EXPERT WITNESS STATEMENT
BY
STANLEY EDWARD DENHOED, P.ENG., M.SC.

HARDEN ENVIRONMENTAL SERVICES LTD.
R.R. 1 , MOFFAT,
ONTARIO, L0P 1J0

2. OPINIONS

Figure 1: Estimated Area Contributing to ESPA 19

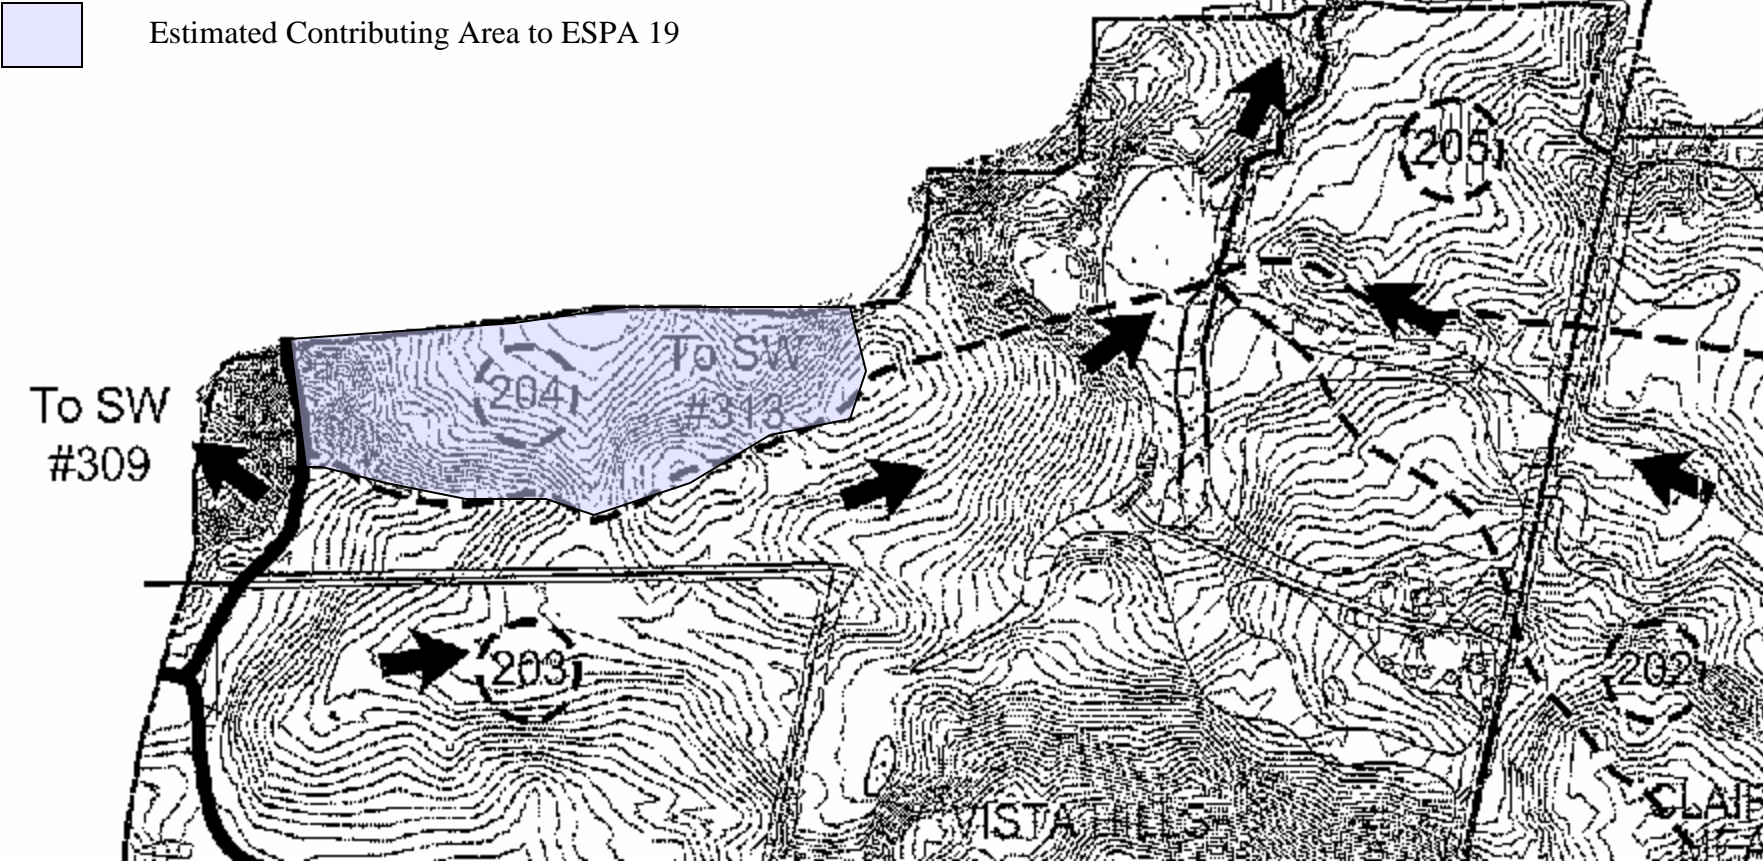
1. The development of the Waterloo West Side Development Lands will remove a significant contributing source area for an environmentally sensitive feature in the Environmentally Sensitive Protection Area 19 (ESPA 19). Specifically, the wetland area identified to me as W-12 within ESPA 19 will have the portion of its contributing source area that falls west of the ESPA 19 buffer area removed during the development of Waterloo West Side Development Lands. That is, water that is presently running off of the Waterloo West Side Development Lands and into the wetland will be diverted into a stormwater management area adjacent to Clair Creek as a

result of the development. Therefore, if the lands are developed and serviced as described in the Preliminary Servicing Report (Stantec, 2005a) there will be a significant decrease in runoff presently supporting wetland W-12. The approximate location of the contributing area that will be lost is shown on Figure 1. During a site visit of ESPA 19 on Friday, July 11th, 2008 I observed runoff from the Waterloo West Side Development Lands into ESPA 19 and this water eventually discharged into wetland W-12, as on Figure 2. It is my opinion that the loss of this substantial portion of the contributing area of this wetland will significantly affect the water balance of this wetland.
